Oyster Creek Generating Station
Facility Operating License No. DPR-16
NRC Docket No. 50219 50-219

Subject: Clarifications to Responses to NRC Request for Additional Information related to Severe Accident Management Alternatives (SAMA) for Oyster Creek Generating Station (TAC No. MC7625)

Clarifications Associated with SAMA RAI Responses

Figure 1c-1 Review Process for Oyster Creek PRA Model

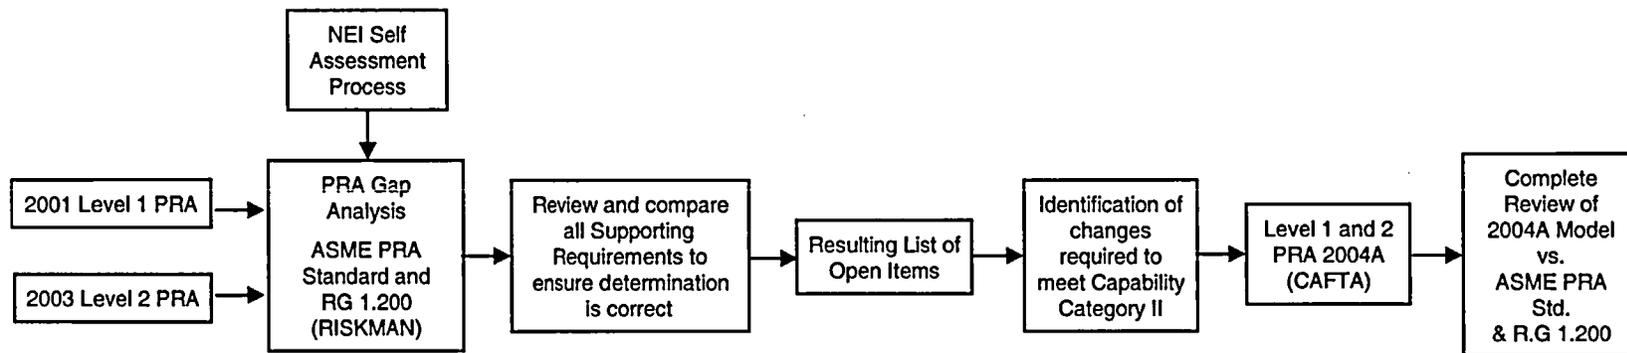
Was the 2004A analysis subjected to a complete self assessment or was the focus of the re-review limited to those gaps found in the 2001 PRA? Of concern is the completeness/applicability self-assessment of the 2001 PRA relative to the 2004A model considering the extensive changes from the 2001 model to the 2004 model not the least of which is the change from support state (RISKMAN) modeling to linked fault tree (CAFTA) modeling.

The Oyster Creek 2004A model, documentation, and results were subjected to a complete self assessment to ensure that they reflected the insights from the RISKMAN model and the model changes made during the 2004A model preparation.

AmerGen performed the analysis of the "gaps" of the 2001 Level 1 PRA and the 2003 Level 2 / LERF PRA relative to the ASME PRA Standard [1] and the RG 1.200 [2] changes by direct comparison between the Standards and the PRA. The NEI self-assessment process was used as a second check, but was not a primary input. It was used to ensure that no deficiencies that had previously been pointed out continued to persist. The assessment was performed on the model and documentation compared with the two documents, Ref. [1] and [2].

The 2004A model was targeted to comply with the ASME PRA Standard. The areas of compliance in the 2001 PRA model were retained and updated using a consistent methodology to meet Ref. [1] and [2].

Following development of the 2004A model, it was then completely re-assessed using the Ref. [1] and [2].

Figure 1c-1 summarizes this process.
